Salvation Army
88 Preble Street
Submittal No: 1
Revision No: 0

**Submittal Title:** Air Supply, Distribution, Ventilation, Exhaust System

PROJECT:	Salvation Army Dining Hall Addition	
SUBMITTAL DATA:	HVAC Power Ventilators	
Owner:	Salvation Army ARC	
Mechanical Engineer:	Ripcord Engineering	
General Contractor:	Benchmark Construction	
(PLEASE INITIAL AND DA	ATE ANY NOTATIONS ON THE SUBMIT	TAL SHEET)
GENERAL CONTRACTOR	ARCHITECT	Γ
		ATTENNA I NO
ENGINEER	_X Revie Make Amen	Corrections noted and & Resubmit ted / Resubmit
	2) <u>10,7 </u> 2 m	- <u></u>

# 41000 SERIES TWO-SPEED NON-DUCTED RANGE HOOD

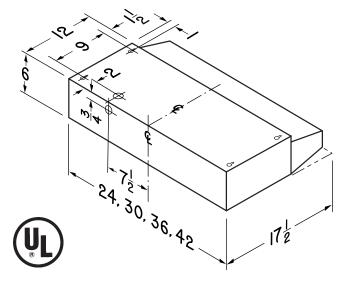
Date_cor.cr_c	Ву	
Engineer			Engineer's Stamp
1. Ensure EF-5 apartme		vidth matches range)	REVIEWED
cabinetry per architectu		rmanae of ashadulad	By Sonia Barrantes, PE at 11:39 am, May 16, 2017
<ol> <li>Resubmit R-1. Need return grille less than a</li> <li>Confirm maximum or</li> </ol>	or equal to NC20	<del>) at 1875 CFM.</del>	30" Hood
are greater than require			
show 800 CFM and 400	<del>) CFM, respectiv</del>	<del>rely (20%), which is</del>	
lower than required.
